BCA ASSESSMENT REPORT

**Stage 1, Talavera Business Centre
4-38 Talavera Road, Macquarie Park**

Revision 0

Date: 07 September 2022

Figure 2 – Perimeter Vehicular Access

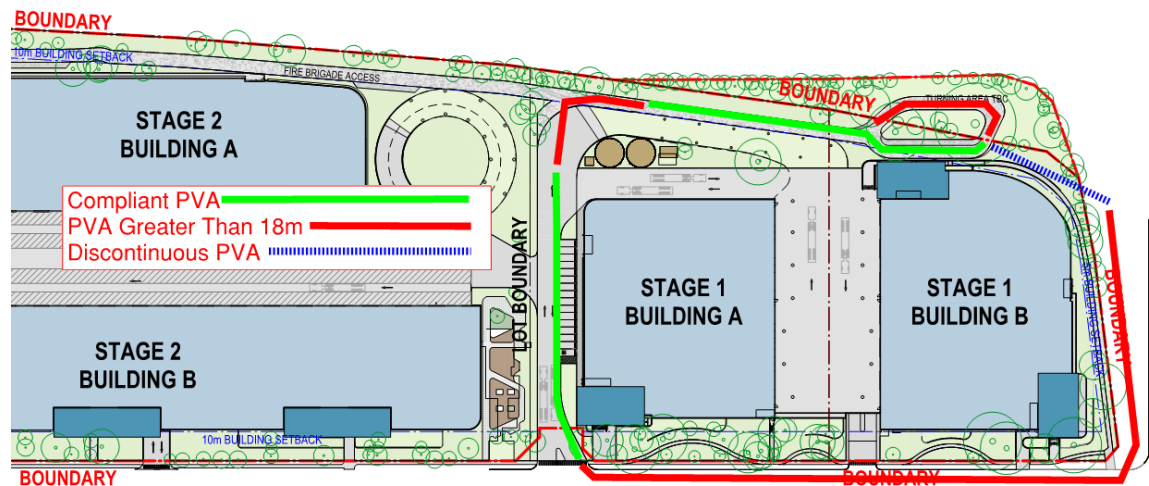
Comments: The proposed warehouse building complies with the provisions of C2.4 with the exception of the areas marked in red, and blue on the mark-up below which are required to be addressed as a Performance Solution by the Fire Safety Engineer. The Vehicular Access is greater than 18m along the north east, south-east and south-west elevations and is discontinuous around the North of Building.

Figure 3 – Separation between Class 5 & 7b Fire Compartments on Ground Mezzanine in Bld. A.

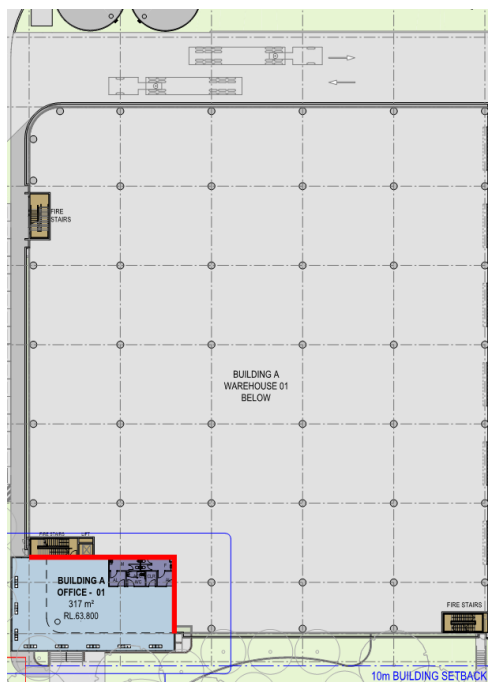
Comments: See comments under Spec. C1.1 regarding FRL requirements, however, the higher Class 7b FRL's can apply to the whole building per C2.8(a) OR in accordance with C2.8(b) a compliant fire wall (240/240/240 FRL) to separate the Class 7b Warehouse from the Class 5 Office on the ground floor Mezzanine and Level 1 Mezzanine will be required (See Fig 3 and Fig 4 below). Details are to be included

Figure 7 – Separation of External Walls between Class 5 & 7b Fire Compartments on Ground Mezzanine in Building A.

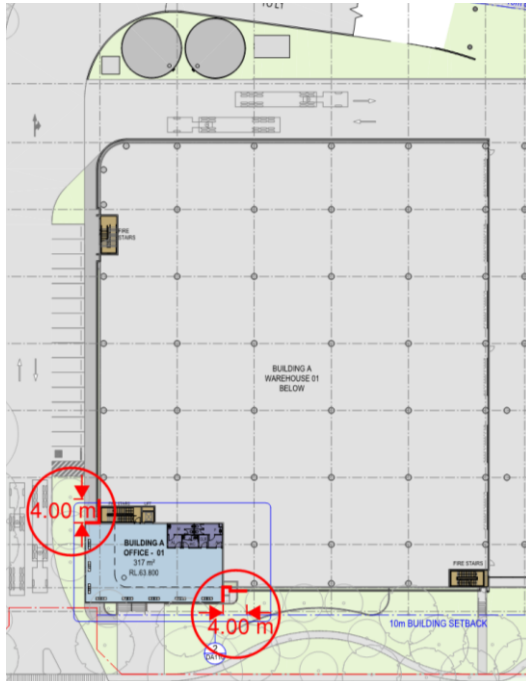
Comments: Where a Clause C2.8(b) Fire Wall between Class 7b & Class 5 parts of the building is proposed in the design the external walls & associated openings on either side of the Fire Walls will require protection per C3.3 for 4m on either side of the intersection of the fire wall (see examples in Fig.7-10 below).

Details demonstrating compliance and/or a Performance Solution from the fire engineer will be required to be provided at the CC Application stage.

Figure 10 –

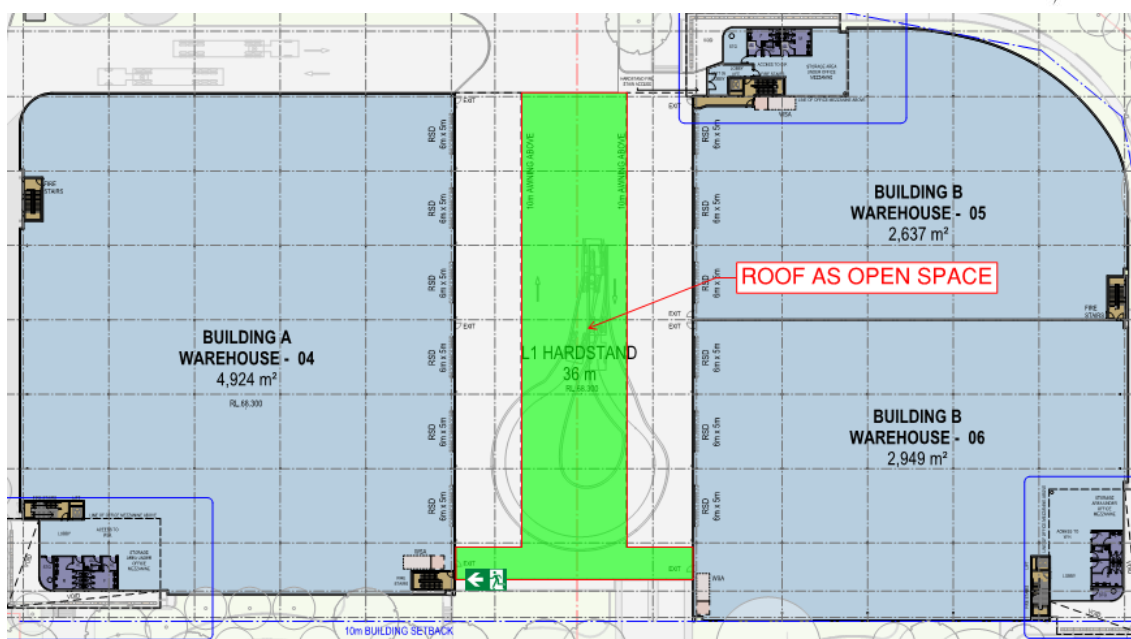
Comments: The hardstand areas shaded in green below are deemed roof as open space and are subject to compliance with D2.12 and also require a compliant external stair or ramp discharge to the Ground Level per D1.10. A Performance Solution will be required from the fire engineer for the use of a fire isolated exit stair as the discharge from the area designated as roof as open space.
